Office Action Summary

10/622,784

UTSUNOMIYA ET AL.

Paper No:04152005
Application No:10/622784
Filing Date: July 21,2003

Fig. 1

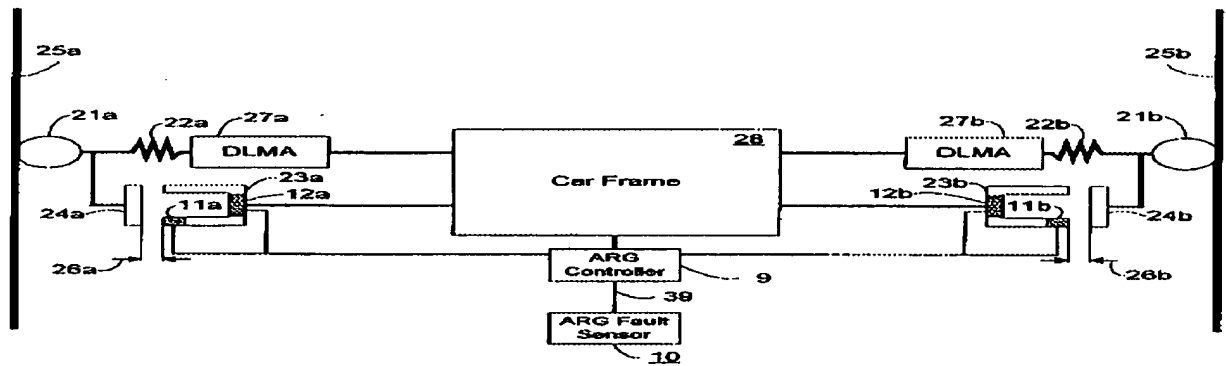
Jamieson et al teaches in figures 1-4, an elevator active guide fault sensor system.

- 1) A vibration magnet 23a,23b contains sensors 11a,11b which control actuators 27a,27b to center the car 28 in the shaftway horizontally. A detection sensor 10 compares the sensor values. If the values fall above a limit 51 the actuator is shut-off 52.

4,6) Two sensors 11a,11b and shut-down stated as within a range (figure 2)
